Call for Review Hillside Development Permit #7134 1530 Scenic Drive

City Council
January 12, 2026

Project Description

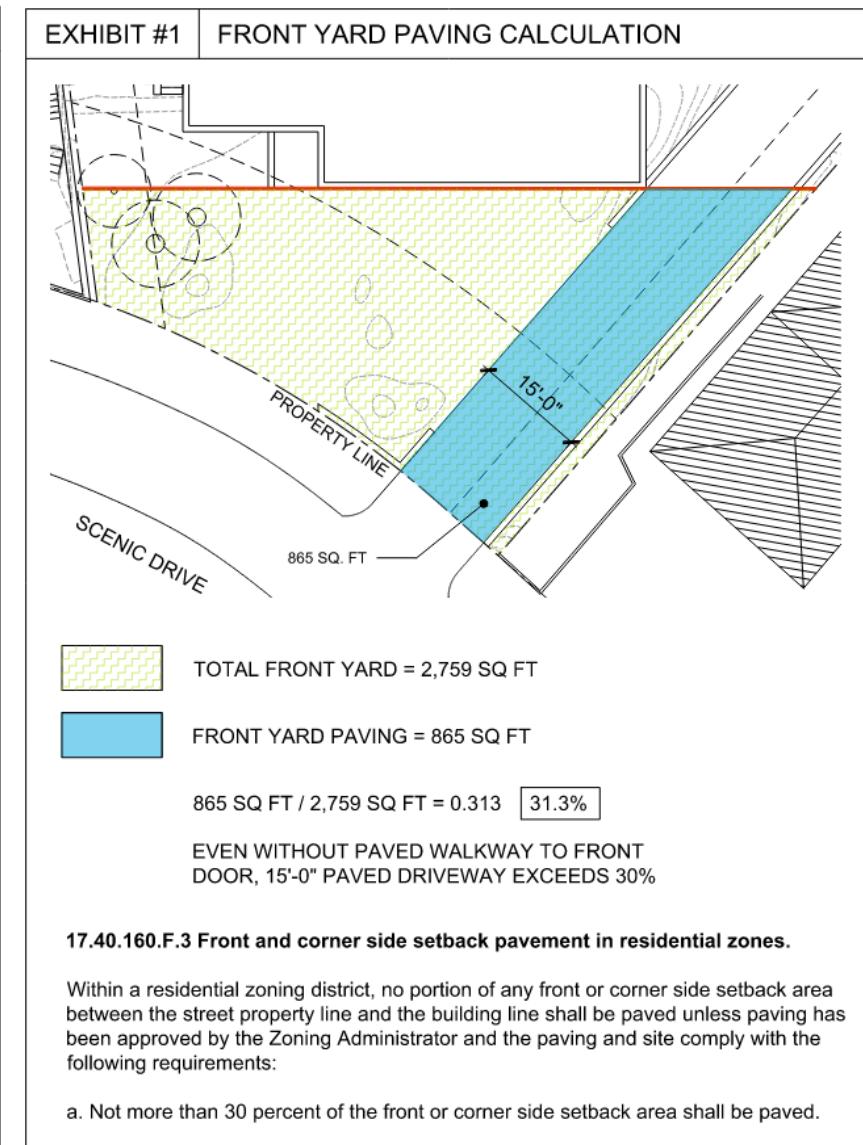
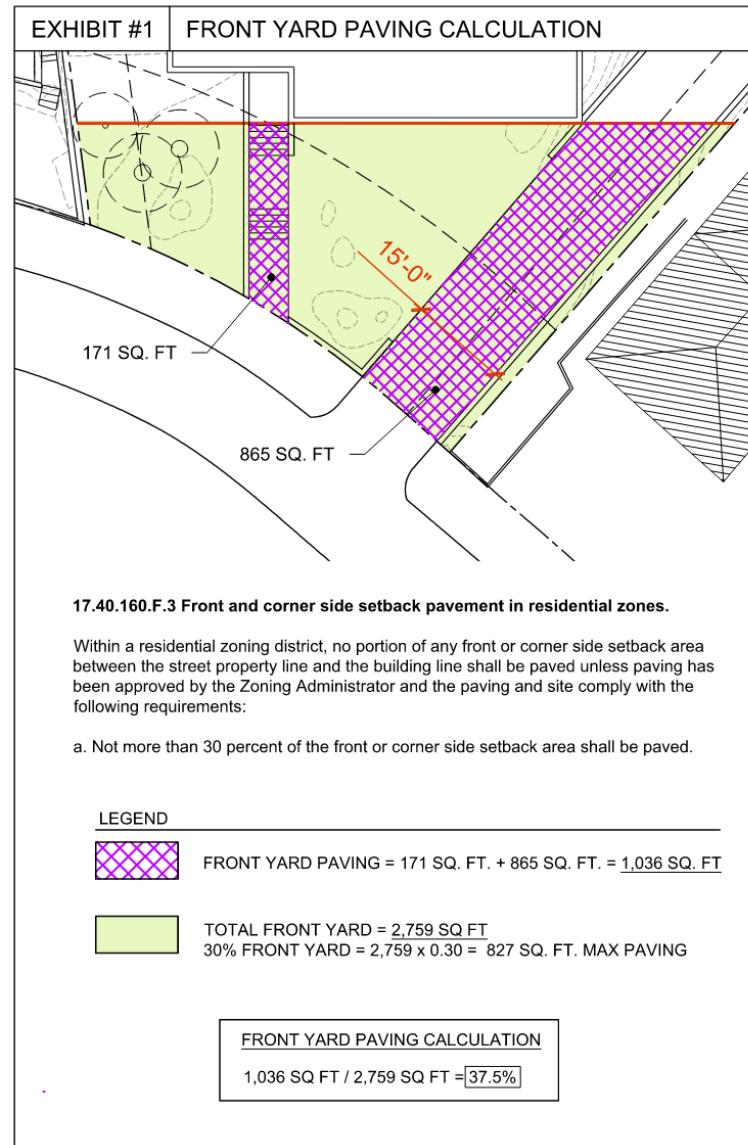
Variance: Front Yard Paving

Applicant proposes a Variance to exceed paving allowed in front yard.

- > Maximum allowed paving is 30% of the front yard (827 sf).
- > The project proposes 37.5 % (1,036 sf) to allow a front walkway and the minimum 15' driveway width.
- > Unique conditions to support the Variance include:
 - Shape of the lot
 - Narrow street frontage
 - Placement of the proposed residence
- > Remaining areas of the front yard will be landscaped with trees, shrubs, and groundcover

Front Yard: 2,759 SQ. FT.

Max Front Yard Paving: 827 SQ. FT. (30%)

Proposed Paving: 1,036 SQ. FT. (37.5%)

209 SQ. FT over the max.

- Driveway: 865 SQ. FT. (31.3%)
- Walkway: 171 SQ. FT. (6.2%)

Tree Removal and Protection Plan

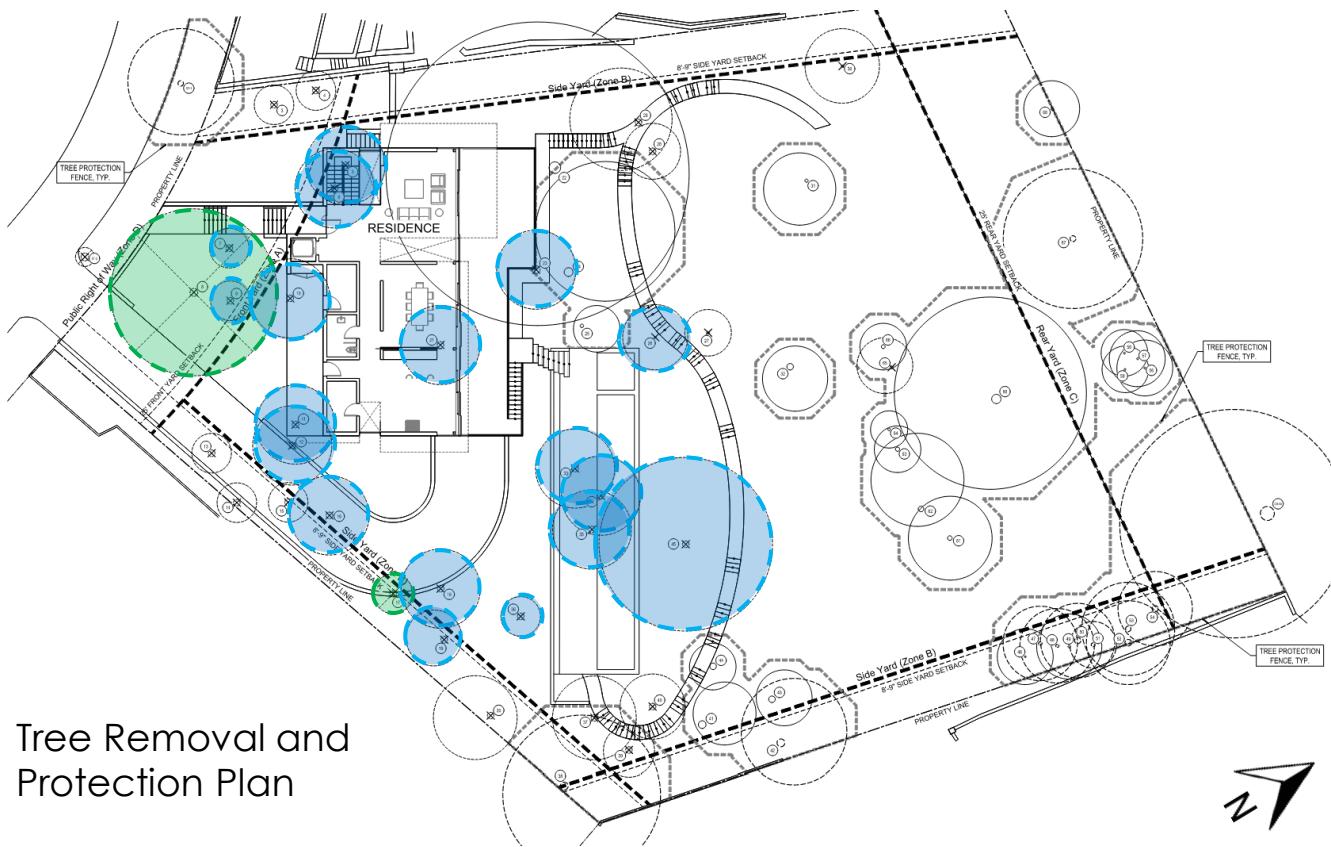
4. **Landscape Plan.** Replacement trees are not sustainable over the long term.

- The project includes a landscape plan, prepared by a licensed landscape architect. Conditions of approval are included to ensure a tree protection plan is provided for existing trees to remain, that the project provide the required replacement trees, and that the trees are planted in a manner that ensures survival.
